PNG AND PNGNE CONSOLIDATED RESOURCE PLAN AND ECI PORTFOLIO	EXHIBIT A-3
---	--------------------

Re: Pacific Northern Gas Ltd. and Pacific Northern Gas (N.E.) Ltd. – Pacific Northern Gas Ltd. and Pacific Northern Gas (N.E.) Ltd. - Application for Acceptance of 2019 Consolidated Resource Plan and for Acceptance of Energy Conservation and Innovation (ECI) Portfolio Funding for 2020 to 2022 – Information Request No. 1

INFORMATION REQUEST NO. 1 TO PACIFIC NORTHERN GAS LTD. AND PACIFIC NORTHERN GAS (N.E.) LTD.

Figure 10: PNG burner tip vs. electricity costs (high carbon price scenario)

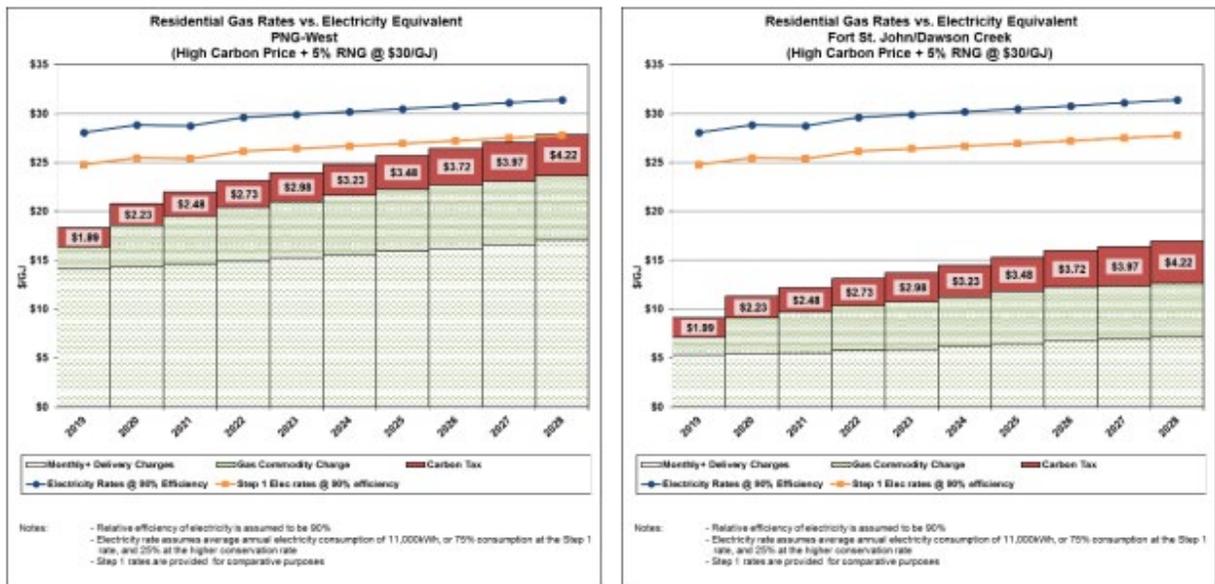
2.1 Please confirm, or otherwise explain, that the RNG supply forecast included in Figure 10 is the same as shown in Table 18.

2.1.1 If not confirmed, please provide an updated graph and/or table.

Figure 42: Small Commercial Customers (Historical and Forecast) – Fort St. John

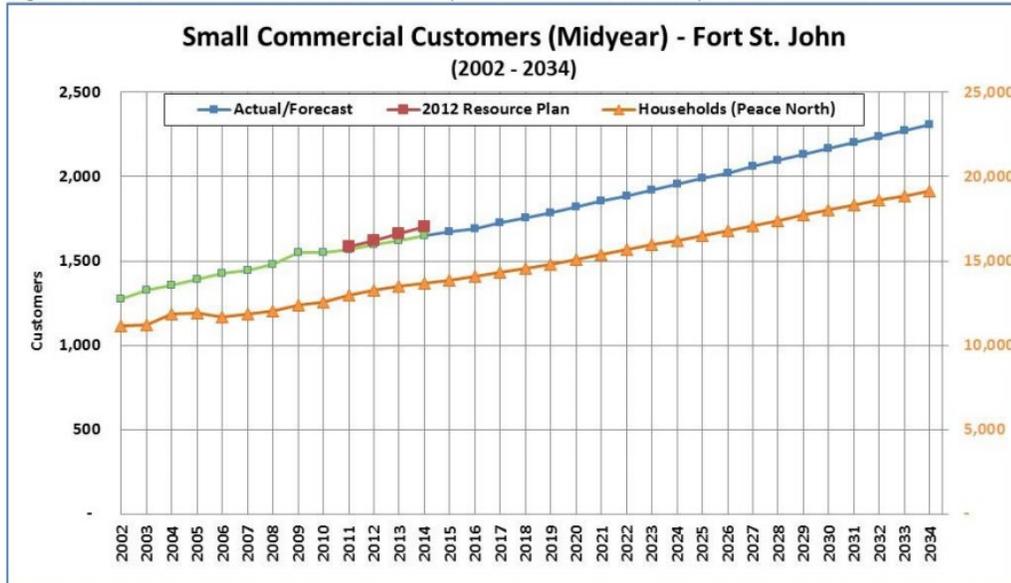
- 16.1 Please provide the most recent correlation analysis between the growth in small commercial customer additions and the trend in household formations for each of PNG’s service areas.
 - 16.1.1 Please provide an explanation for any changes between the most recent correlations and those in the 2015 PNG(N.E.) Resource Plan.
- 16.2 For each of PNG’s service areas, please provide a graph in a similar format to Figure 42 above, demonstrating the historical and forecasted correlation between the growth in small commercial customer additions and the trend in household formations for the period 2002 to 2038. Please include forecasts provided in PNG’s two most recent resource plans.

Figure 37: Forecast small commercial use per account (Fort St. John)

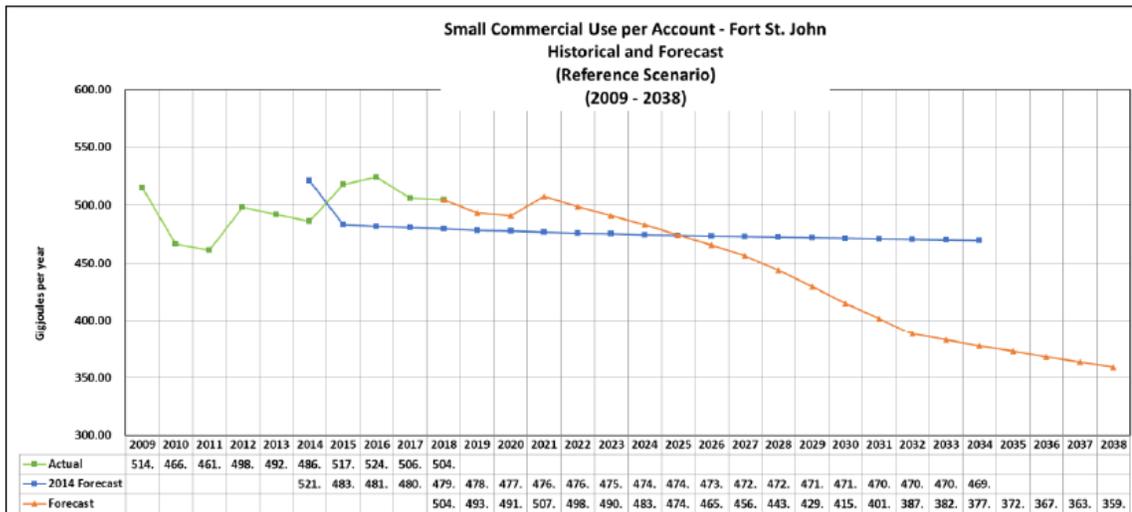
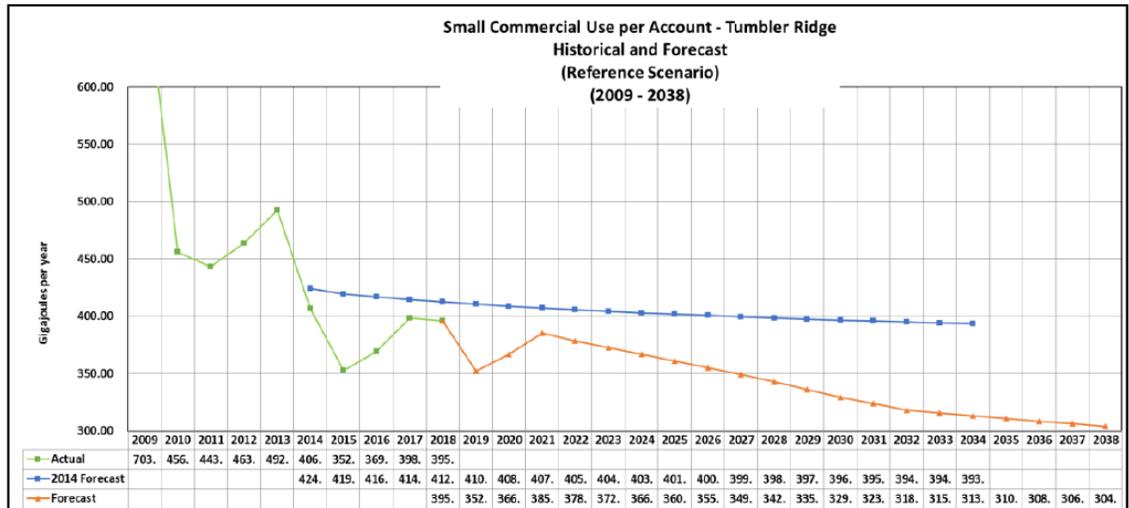
- 17.3 Please explain the reasons for the forecasted decrease in small commercial UPA for both Fort St. John and Tumbler Ridge.

Figure 51: Large Commercial demand – Fort St. John

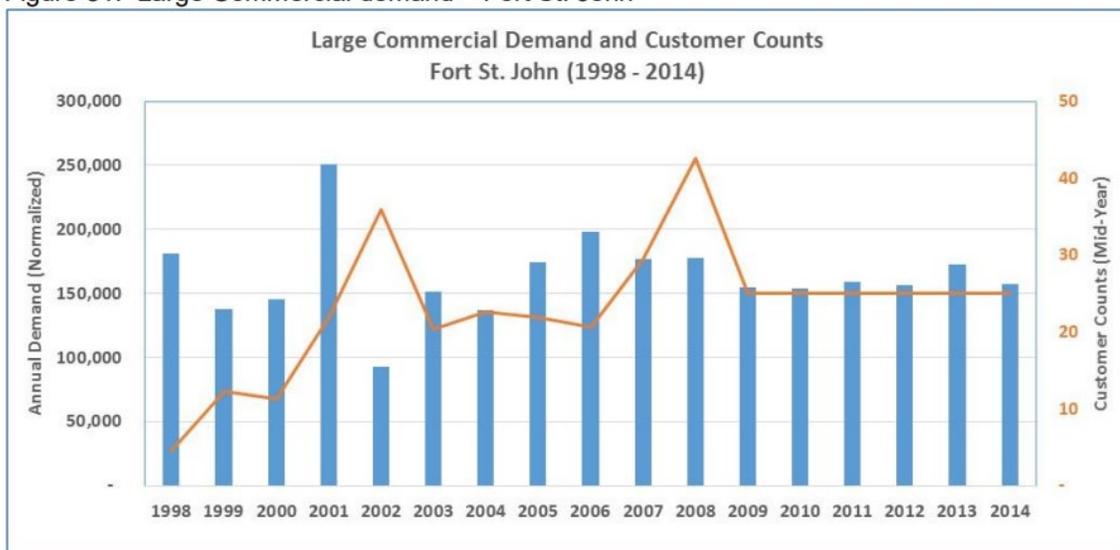
- 18.4 For each of PNG’s service areas, please provide a graph in a similar format to Figure 51 above, comparing the historic actual large commercial demand and customer counts with the forecasts as provided in previous resource plans for the period 2009 to 2019.

Figure 9: PNG burner tip vs. electricity costs

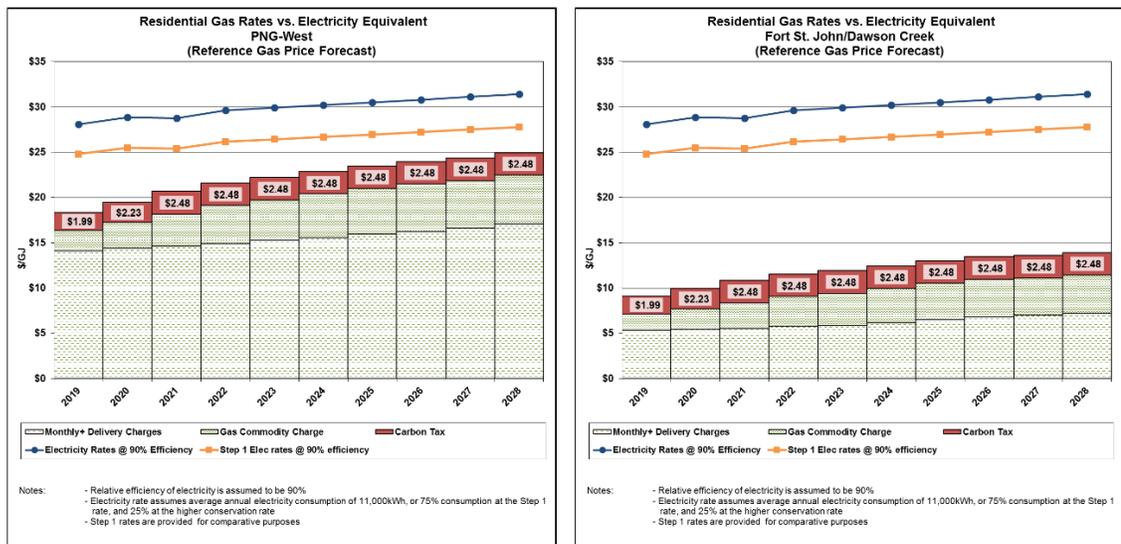
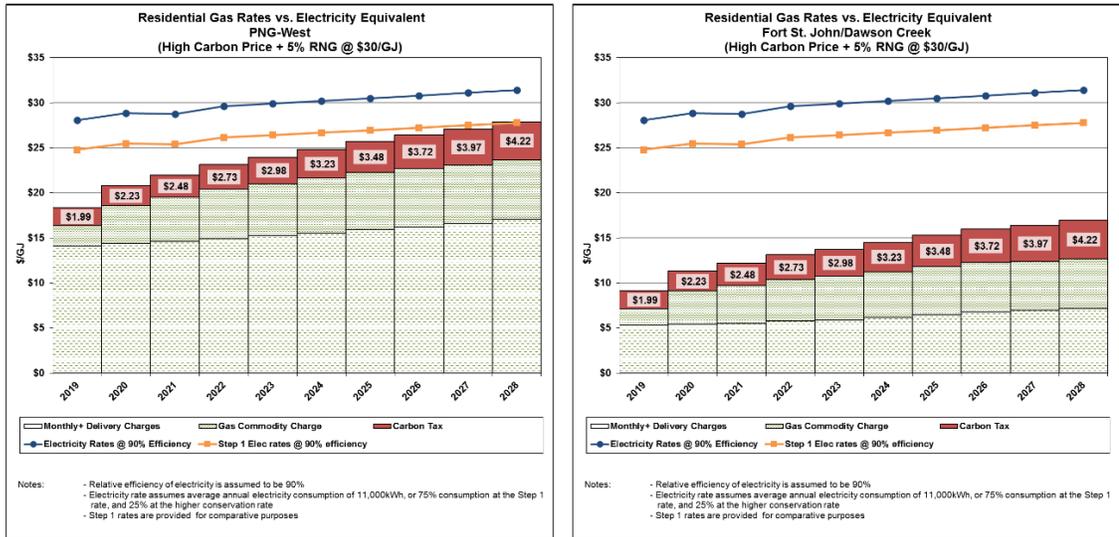
32.2 For each service area, please provide a comparison of the natural gas rates versus the electricity equivalents, adjusting the Monthly Delivery Charges to represent the demand forecasts under the Reference, Competitive Gas and Competitive Electricity scenarios. Please provide a comparison for (i) Residential; (ii) Small Commercial Customers; and (iii) Large Customers.

32.2.1 Based on the analysis, please discuss whether there is a point at which the rates would be considered uneconomical for PNG’s customers, resulting in a higher rate of customer losses.

Figure 64: Forecast Gross and Net Annual Demand (TJ)

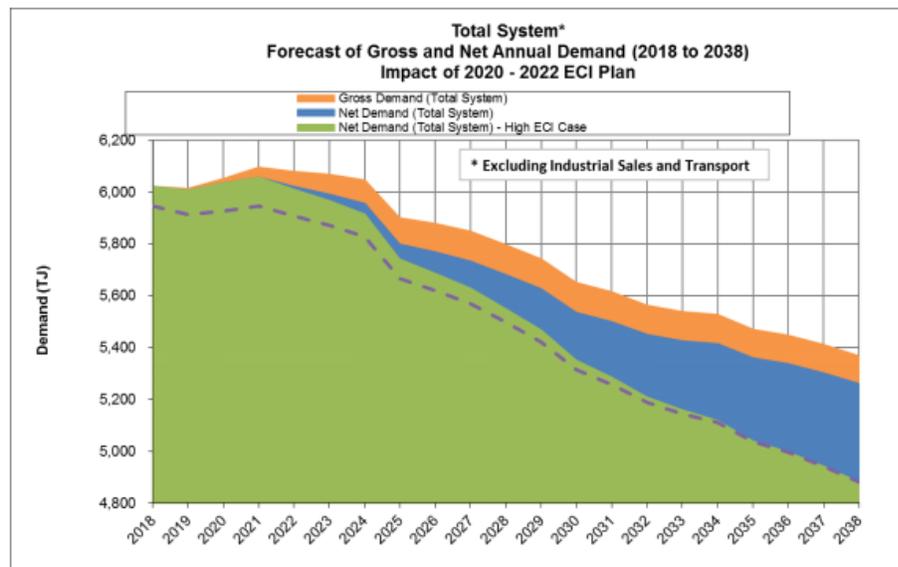
- 36.1 Please clarify the purpose of the dashed line on Figure 64.
- 36.2 Please explain on what basis PNG has assumed market saturation will occur after 2027 in the reference scenario.

Figure 11: AECO-C Natural Gas Price Forecasts

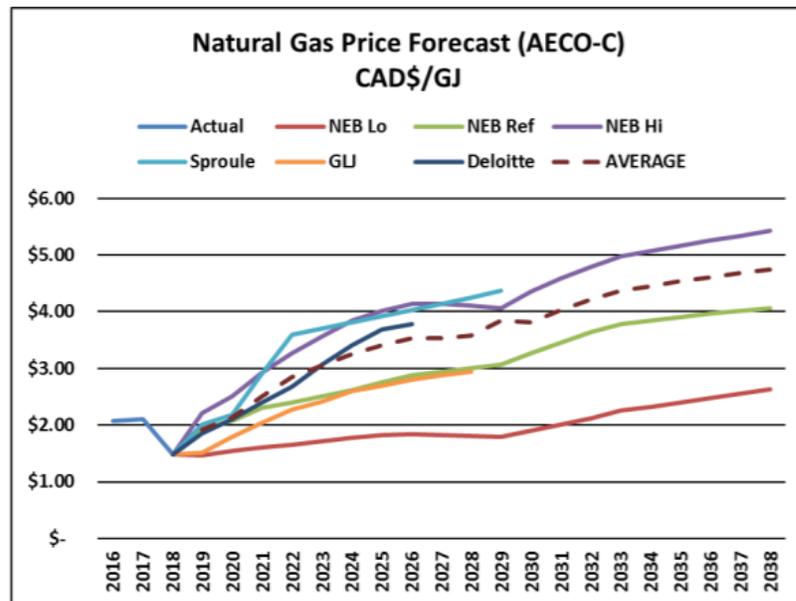
- 40.4 Please update Figure 11 to include Station 2 prices, based on the same NEB and industry forecasts.
- 40.5 For each of the gross demand forecasts developed for PNG-West and PNG(N.E.), please assess the set of alternative resource portfolios that match the forecast against the objectives outlines in Section 1.4 of the Application. In your response please provide:
